PCN – Product Change Notification

PCN-A-110803

PCN Topic: Update 8.4 inches Panel Mount Drawing_R08T200-PMT1

Old Mechanical Design:

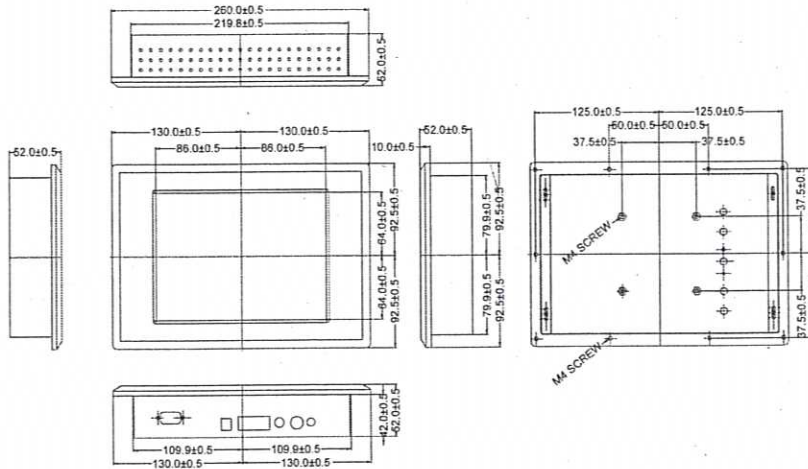
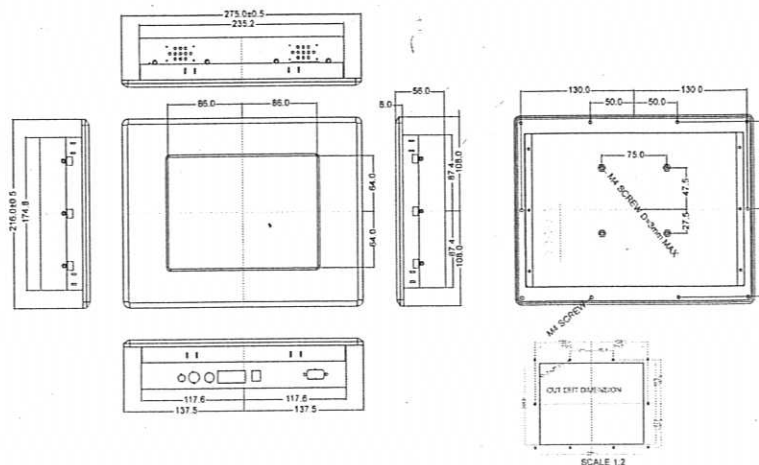
The Aluminum Front Bezel thickness of this model will be changed from 10mm to 8mm and the whole dimension will be slightly expanded. The below pictures show the example of how the new drawing differ from the original one.
